DISCUSSION

PCI Design Handbook Appendix A: Blast-resistant design of precast, prestressed concrete components

Comparison of details for controlling end-region cracks in pretensioned concrete I-girders

Figure 1. Illinois 48 in. pretensioned girder. Note: F_{si} = design pretension force before transfer. Grade 250 = 1720 MPa; Grade 270 = 1860 MPa; 1 in. = 25.4 mm.

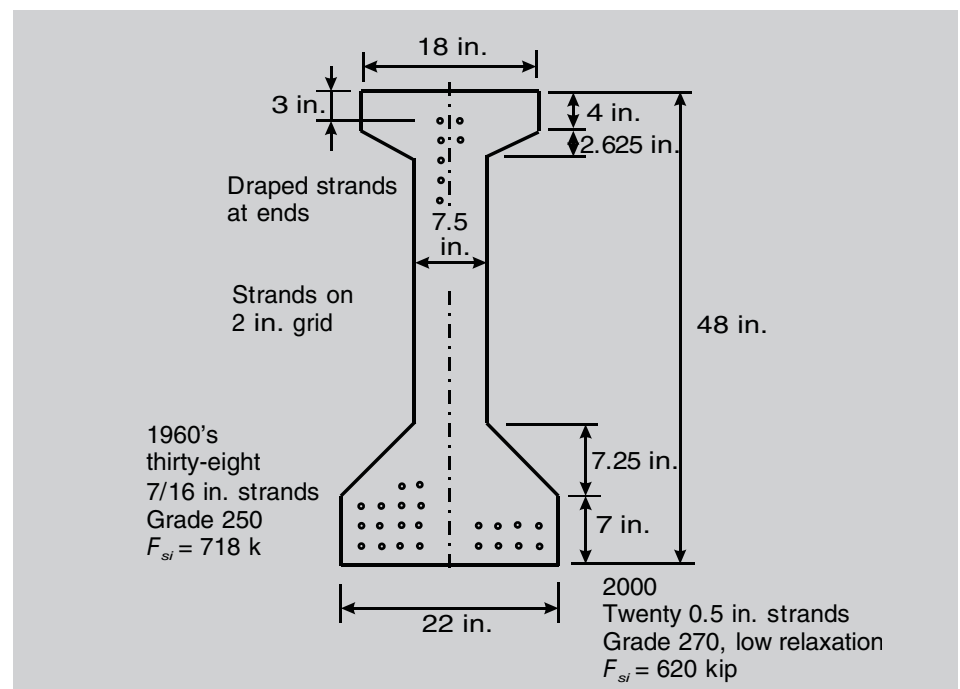
Both *PCI Journal* papers reference the AASHTO LRFD anchorage zone reinforcement requirement of 4% of the prestressing force,⁶ to be resisted by deformed bars at 20 ksi (140 MPa). I find the retention of this value, which is carried over from earlier AASHTO specifications, to be puzzling because it recognizes neither the cross section shape nor the strand arrangement. The provision is also slightly ambiguous in that it does not state whether the prestressing force before or after transfer is to be considered. I have used the pretransfer value because it is slightly more conservative.

The cross section shown in Fig. 1 can be used to illustrate the problems with the 4% rule. The left side of the drawing shows the 1960s steel arrangement used for a beam with a span of about 72 ft (22 m) and a beam spacing of 8 ft (2.4 m). The right side shows the equivalent steel arrangement from the year 2000. The larger, stronger strands lead to a significantly greater eccentricity and, thus, to a smaller initial pretensioning force. The low-relaxation material also contributes to the reduction. The forces noted as F_{si} are the design pretensioning force, before transfer. On the basis of the 4% rule, the new design requires less end-zone reinforcement.

Gamble discusses the 4% rule from the *AASHTO LRFD Bridge Design Specifications*.² This approach for designing splitting resistance in pretensioned anchorage zones (in other words, vertical end-region reinforcement) originates from a model created by Marshall and Mattock³ in the early 1960s. In presenting their model, Marshall and Mattock use the prestressing force at transfer to calculate the requisite vertical reinforcement, an approach consistent with Gamble's calculations. The Marshall-Mattock model was based on experimental data, and as Gamble's analysis has demonstrated, it may not be suitable for modern girder design and materials.

Figure 2. Results of Gergely analysis of girders.

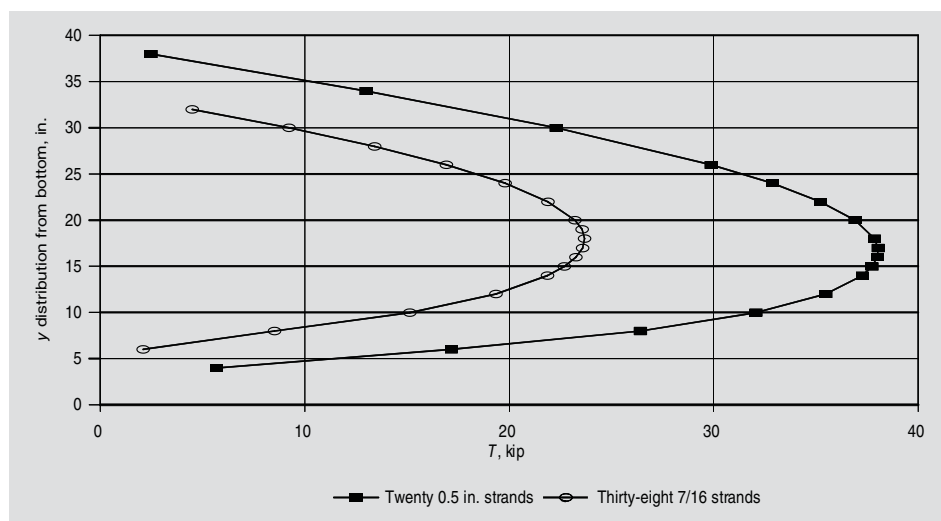
However, a Gergely-type analysis gives a quite different outcome. **Figure 2** shows the results of Gergely analyses for the two different cases. The case with twenty 0.5 in. (13 mm) strands has a tension force that is much larger than the earlier design and much larger than the 4% rule requires. Four percent of 620 kip (2800 kN) is 24.8 kip (110 kN), while the Gergely analysis gives a force of 38 kip (125 kN). The 4% rule is safe for the earlier case because 4% of 718 kip (3190 kN) is 28.7 kip (128 kN), while the Gergely analysis gives a maximum force of 23.7 kip (105 kN). A Gergely-type analysis is not too difficult, but it does require many details of the cross sections, including the area, moment of inertia, centroid, and the detailed variation in width of

the section in the lower part of the member. The FIB-63 member is a bit messy in this respect, while the Alaskan Way super girders are fairly straightforward. While the Gergely analysis is mentioned in both papers, it is not clear whether it was actually used. The results might have been instructive.

Regarding Gamble's question as to the application of the Gergely-Sozen⁴ model to the FIB test specimens, we did not conduct a Gergely-Sozen analysis of our specimens; however, a finite element model was developed in recent work by Willis.⁵ The
